Car Stereo
Service Bulletin

Model: CDX-U70/U300/U303

No. 298

Subject: Head Unit May Not Turn On If CD Changer Is Connected.

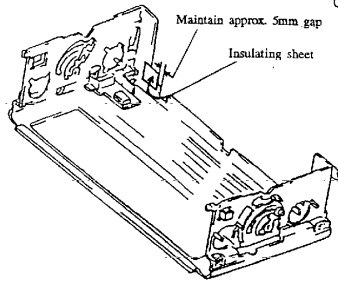
If one of the above mentioned CD changers is connected to a Unilink head unit, the head unit may not turn on.

If this symptom is observed, inspect the Jack flexible board for signs of chafing which may be caused by the flexible board rubbing against the metal chassis. If damage to the flexible board is found, replace it and prevent the problem from re-occurring by adding an insulating sheet to the metal chassis.

REF	DESCRIPTION	PART NUMBER
-	INSULATING SHEET	3-327-119-01

If the insulating sheet is unavailable, the repair can be made by applying any insulating tape to the chassis as shown below
